Harris Realistic LBLOCA Question Response Meeting

January 11, 2012
Rockville, MD

Overview of Question Response

Maximum Packing Factor [PF] Considerations

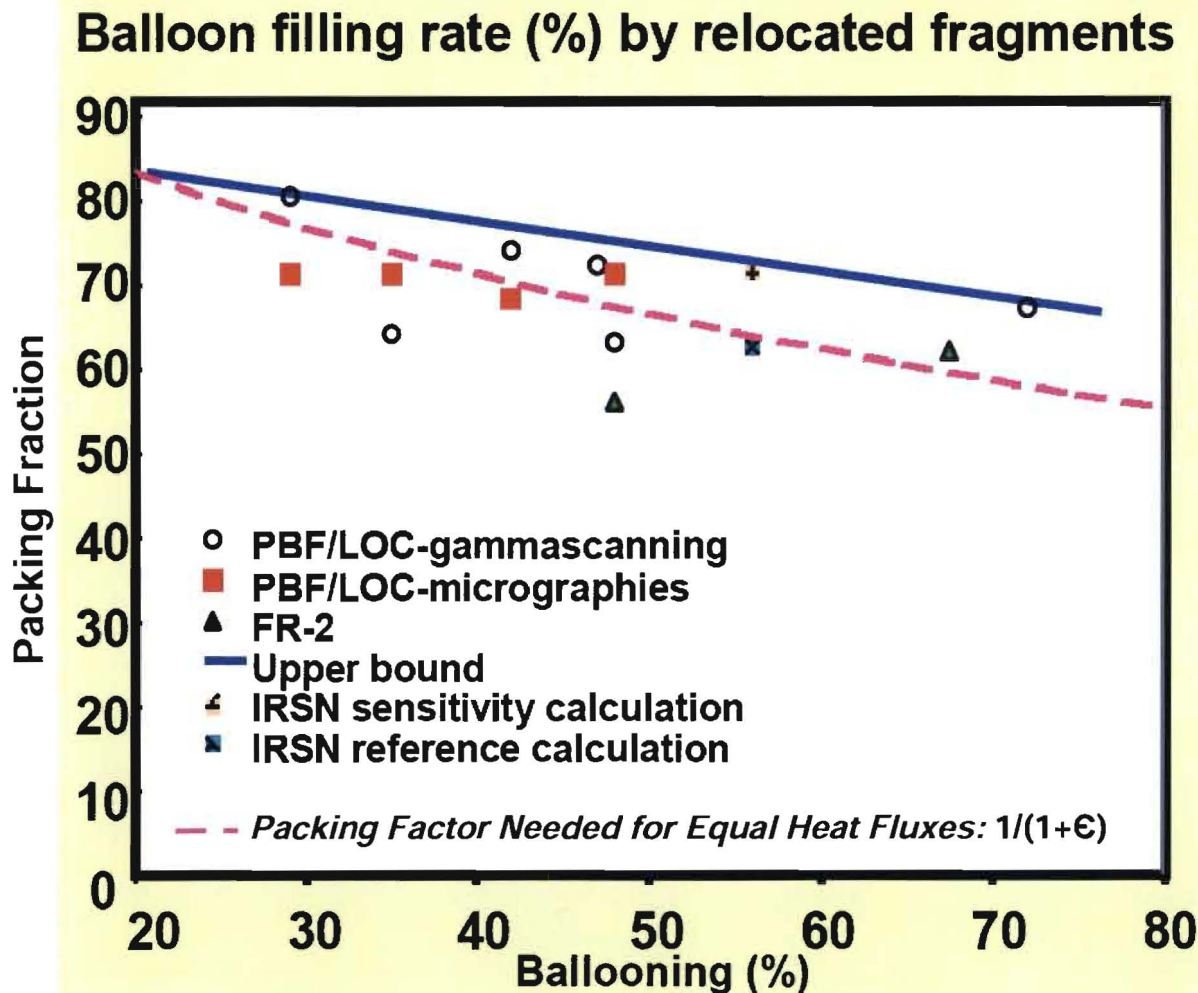
- Characterize droplet shattering model without modeling the fuel relocation
- Show the sensitivity of the fuel relocation to fuel relocation packing factor
- Consider including a range of packing factors 30 - 80%
- Utilize the Harris Nuclear Plant (HNP) limiting-peak clad temperature (PCT) case

PBF – Power Burst Facility

- Only 1 gamma scanning data point at 80% packing fraction and it is at 30% strain
- Data results are in question due to material movement during the handling of the test rods
- Micrographies measurement is more accurate compared to gamma scanning
- PBF micrographic data shows 70% PF for rupture strain below 50%
- AREVA estimates 45% PF for strains near 70%

REBEKA-6 Test: Rupture rod cladding temp. & pin pressure

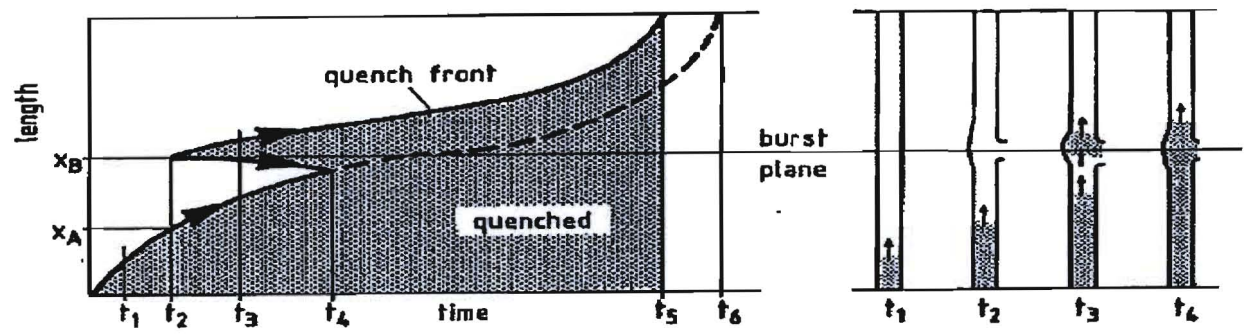
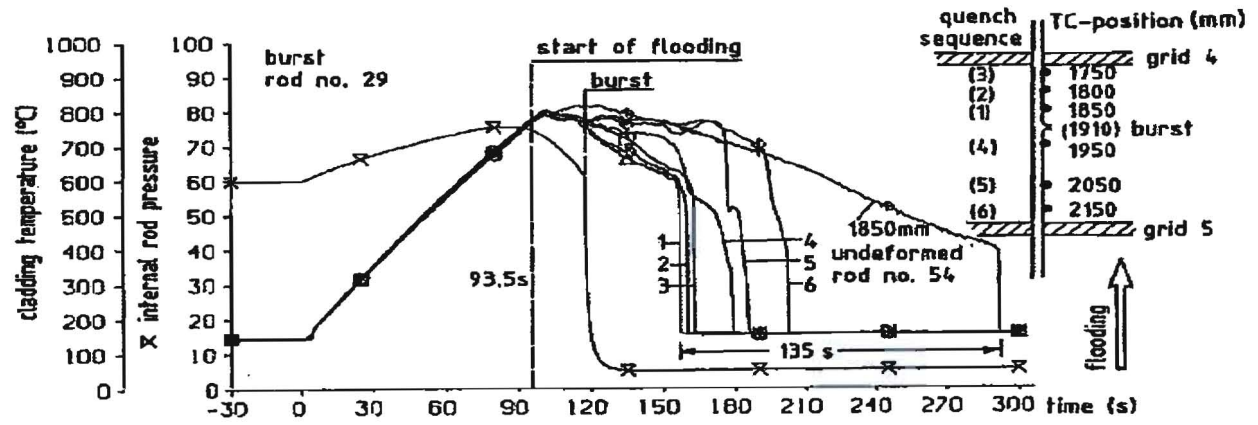
Explain how droplet shattering model incorporates the following droplet-dependent heat transfer effects:

- Inter-phase heat transfer
- Fluid-structural interactions including cladding, balloon, and spacer heat transfer to coolant
- Validate heat transfer modeling for these separate effects

Fig. 7 Premature quenching of burst Zircaloy claddings (schematic)
